**New information on
Planning applications by Cuadrilla Bowland Limited to drill at
Preston New Road (no. LCC/2014/0096)
and
Roseacre Wood (no. LCC/2014/0101)
Objection on grounds of geology and hydrogeology
by
Professor David Smythe
Emeritus Professor of Geophysics, University of Glasgow**

Summary

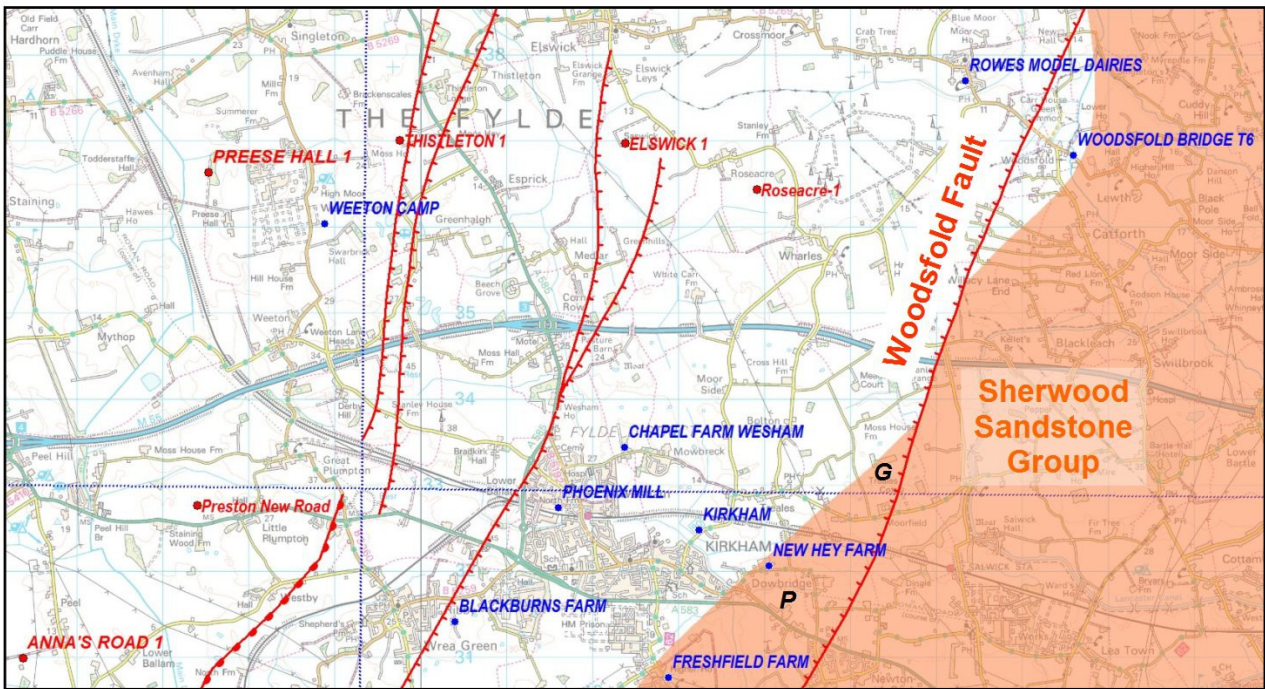
Figure 1 shows the location of some of the water wells labelled in blue, and the exploration boreholes, actual and proposed, labelled in red. The area where the MMG is at the surface (outcrop below recent glacial deposits) is uncoloured. The SSG outcrop is shown in a buff colour. Major faults as mapped by the BGS at the surface are shown in red with a comb on the downthrown side. The Principal Aquifer lies generally east of the Woodsfold Fault, and the abstraction wells here are generally drilled to 100 m or shallower depth.

The BGS solid geology maps show the Woodsfold Fault cropping out as a nearly straight line, as shown in Figure 1. But the actual location is poorly defined, because surface geological exposure is extremely limited, and the seismic information is very poor. Evidence for uncertainty includes the fact that the recent deep mapping by the BGS using seismic data conflicts to some extent with the surface maps, by up to 1 km. The interpreted sliver of MMG on the east side of the Fault, where the Woodsfold Bridge well is situated, is somewhat unsatisfactory; a better explanation of the surface geology is to place the Woodsfold Fault at outcrop just east of the water well. This solution would accord better with the recent BGS deep mapping using 2D seismic data.

Further south, the outcrop of SSG west of the Woodsfold Fault is unsatisfactory. It straddles two geology sheets; a small triangular area on the Garstang sheet, marked with a G on Figure 1, and the larger area P to the south. The Garstang sheet dates from 1990. The sliver of SSG in the Preston sheet may have been added as a new interpretation following the drilling of the Freshfield Farm well in 1988, discussed above. This interpretation is present in the BGS digital database, but has been removed from the new

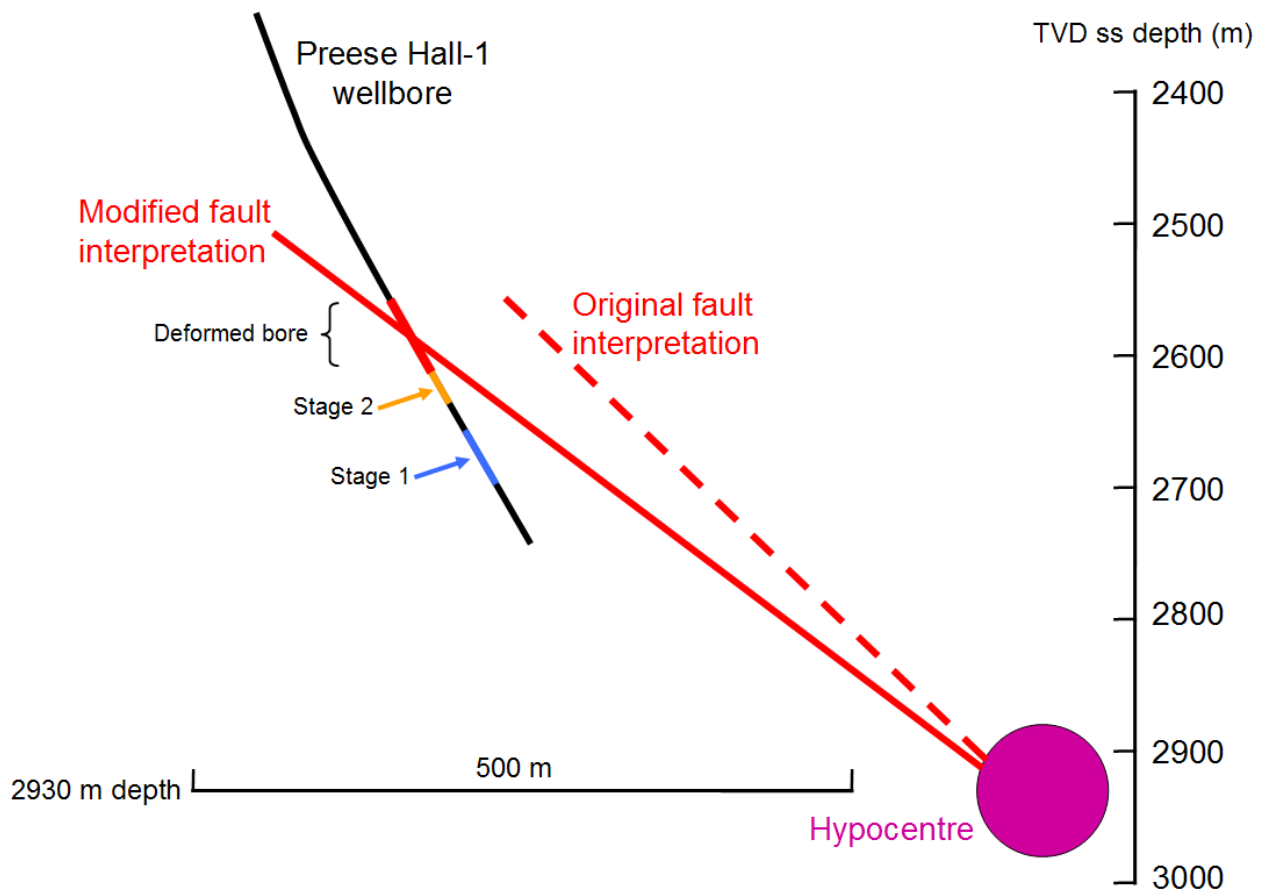
The earthquake location on a fault plane, the hypocentre, is shown by the lilac ball (Fig. 2). The extrapolation upwards of the fault plane misses the wellbore, according to the original interpretation of Clarke *et al.* According to them the fault is shown on the 3D seismic data volume running upwards to the west from the hypocentre, but dying out about 100 m east of the wellbore (the dashed red line in Fig. 2). Such an interpretation mismatches the seismic data, because the dashed line representing the fault in Figure 2 cuts across the westerly-dipping seismic layering. I have re-interpreted the fault position (Smythe, for submission) to honour the seismic data, as shown by the solid red line in Figure 2. This version is consistent with the earthquake focal plane solution, and intersects the wellbore. It also shows that the fault runs through the well in the zone where the well casing was deformed. The earthquakes and the deformation happened shortly after frack stage 2, shown in yellow on the wellbore (Fig. 2).
